Botley West Solar Farm

Applicant's Responses to Local Impact Reports Submitted
at Deadline 1

PINS Ref: EN010147

Document Ref: EN010147/APP/12.3

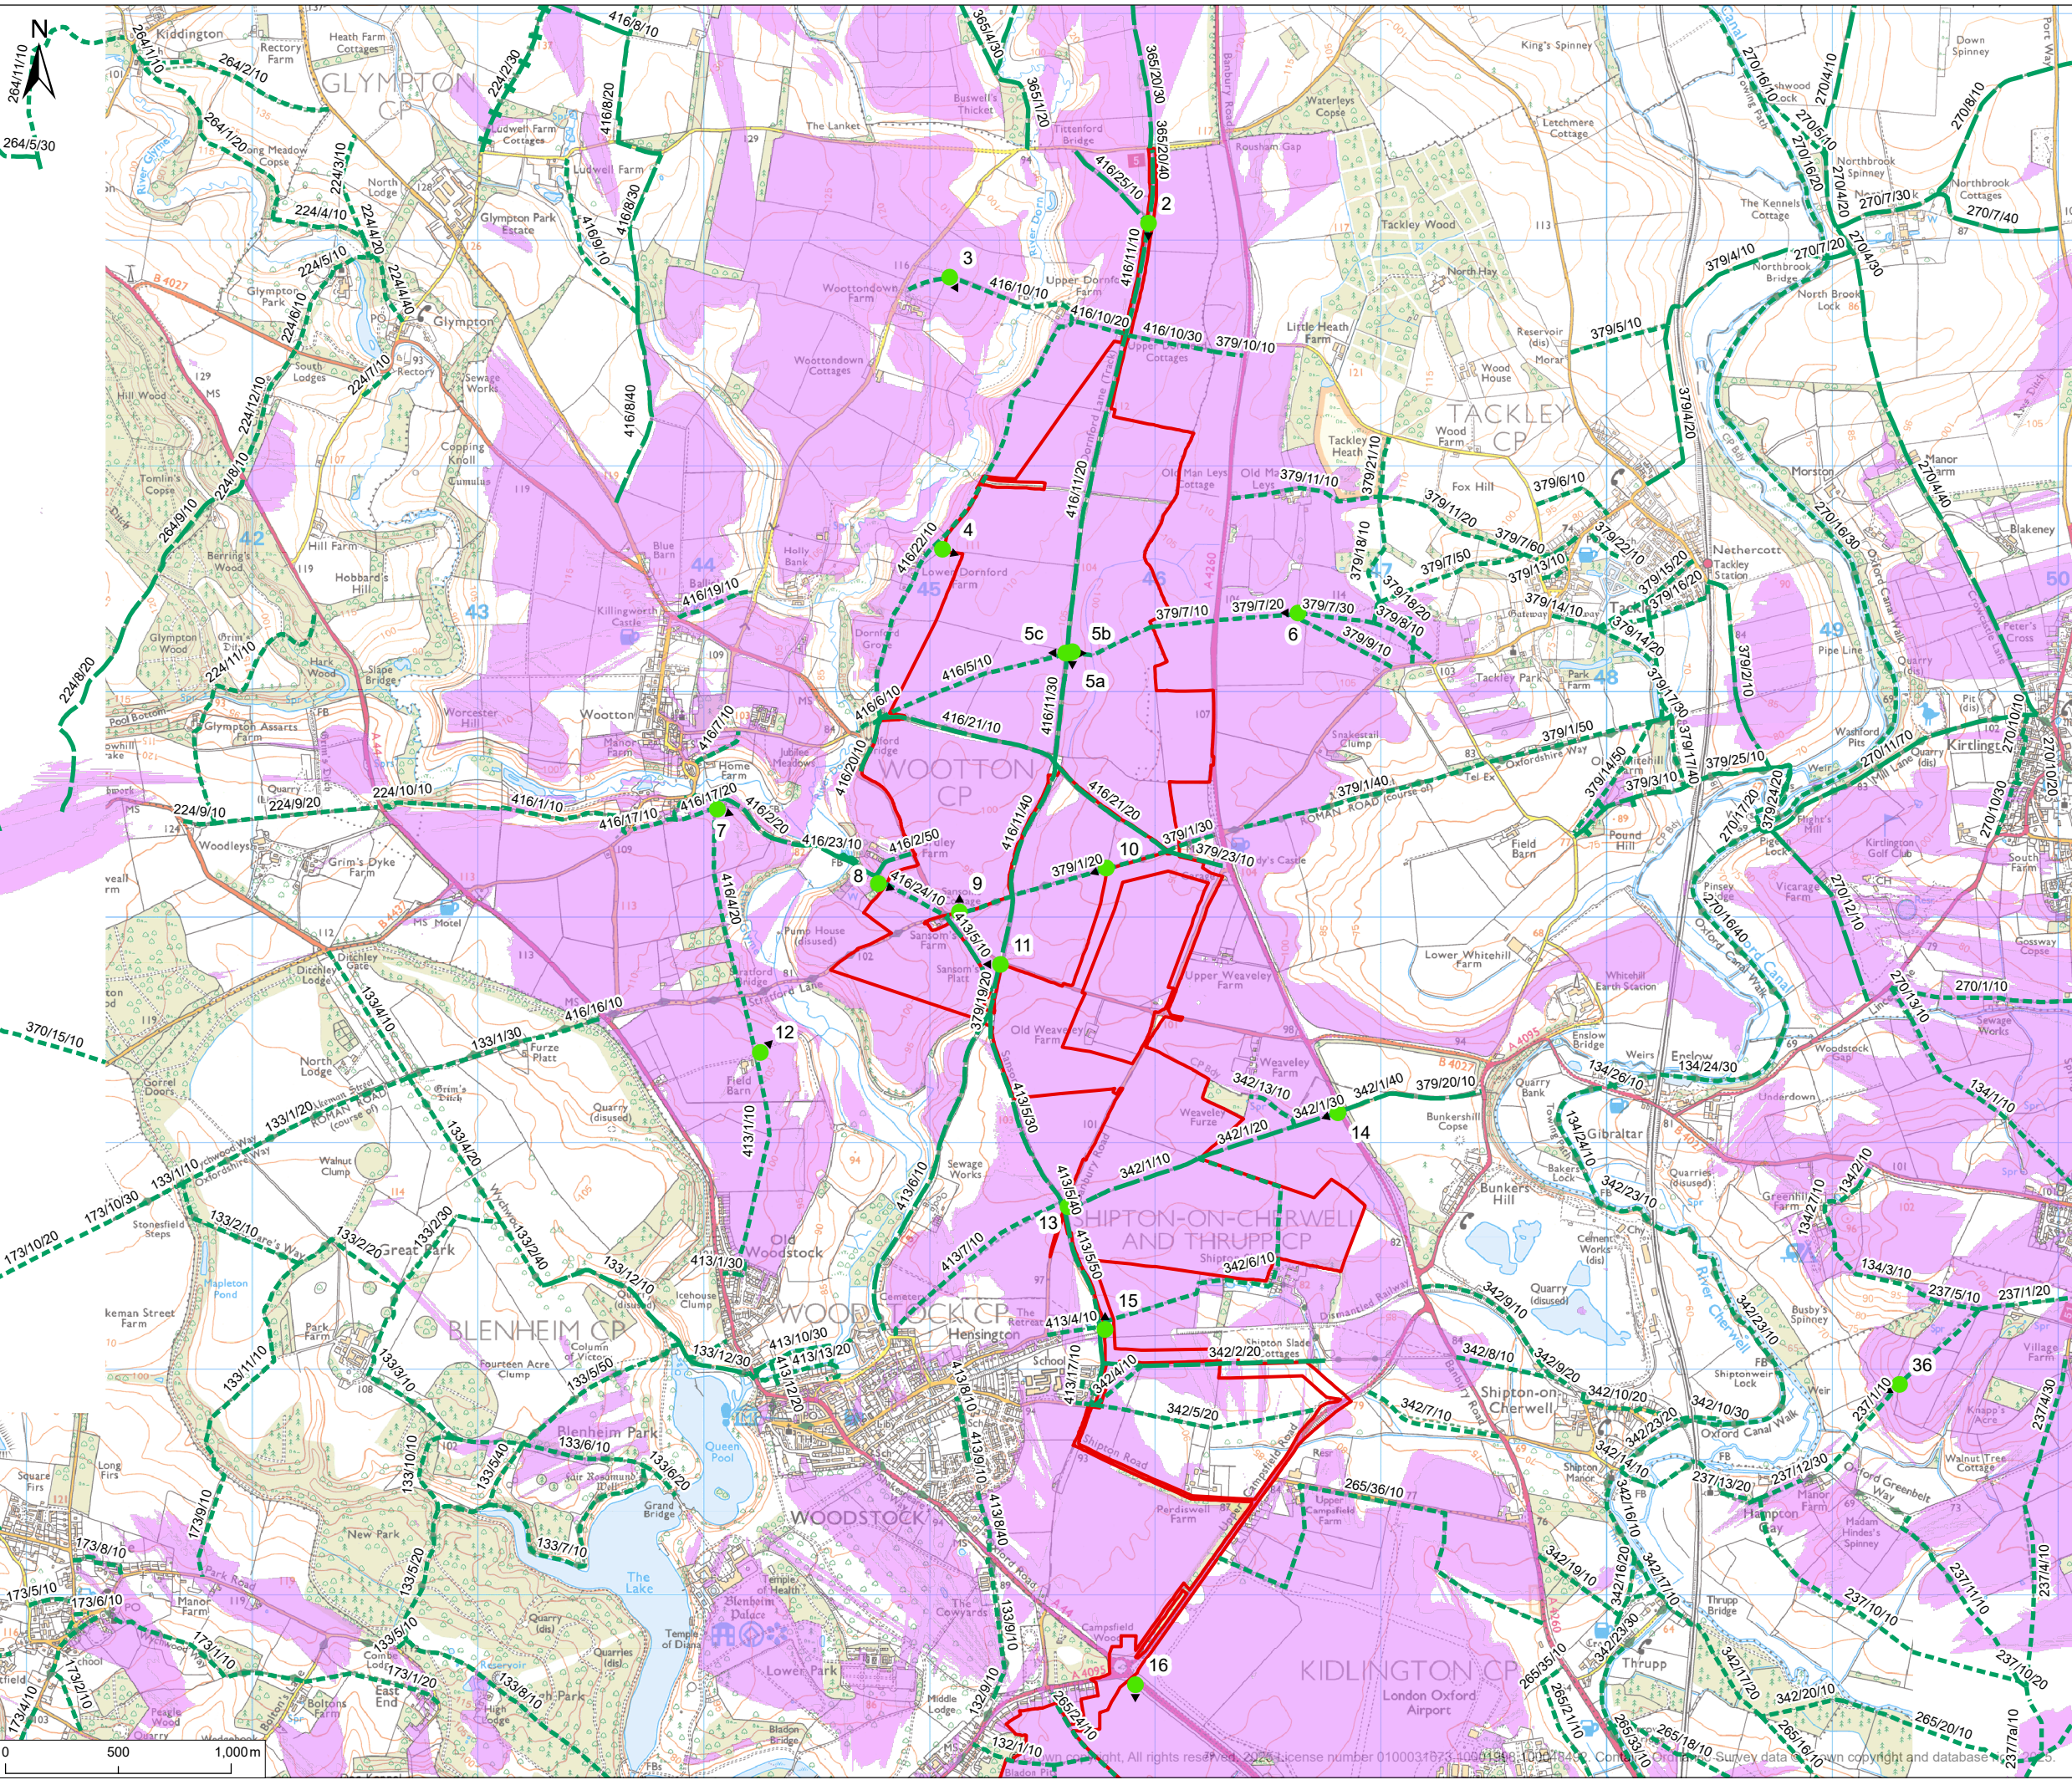
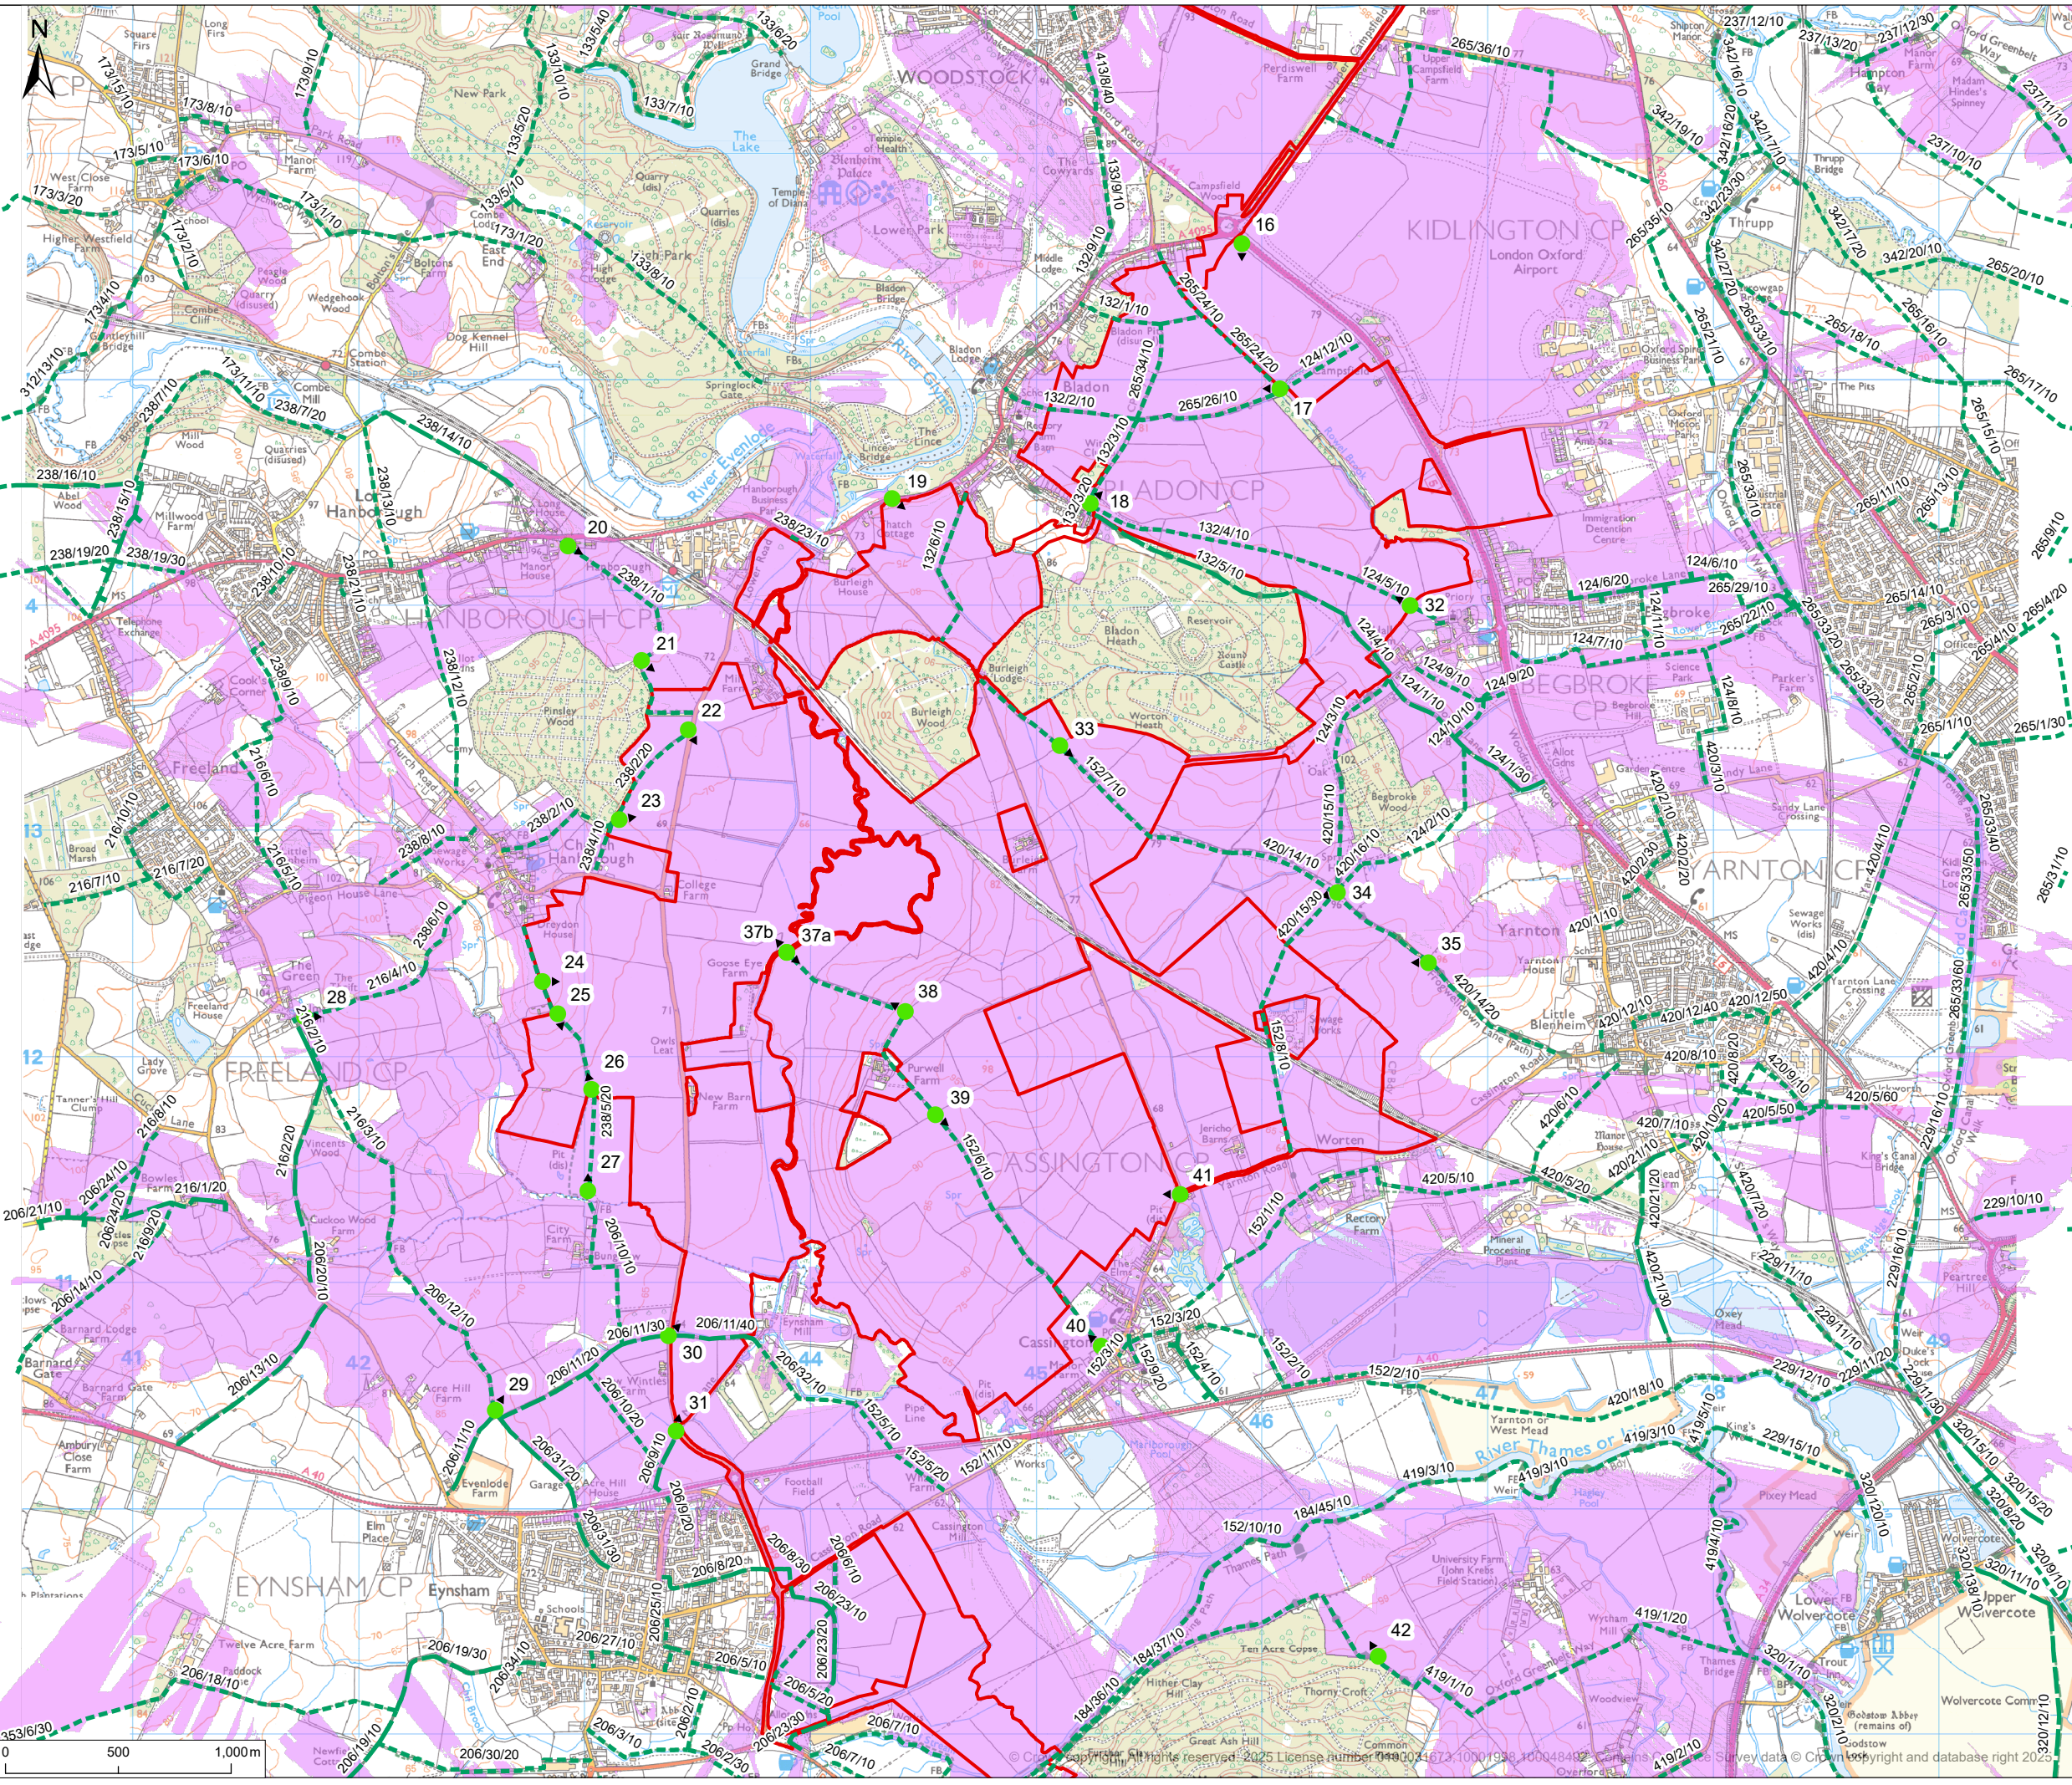
| Name | Comment | Applicant's Response | Issues |
|--|---|--|------------------------------|
| Joint Local Impact Report of CDC, VWHD, WODC and OCC | 7.3.56 The LVIA information is not easily accessible, and it would be helpful to have a plan that includes the Masterplan Layout, Viewpoint locations and the PRoW clearly marked and numbered, to help with the understanding of the submitted visualisations | Figures showing the ZTV, the labelled PRoW and the viewpoints on 1:50,000 OS mapping are provided with this response (appended as Figures 12.3.1 to 12.3.3 of this document). | Landscape and Visual Impacts |
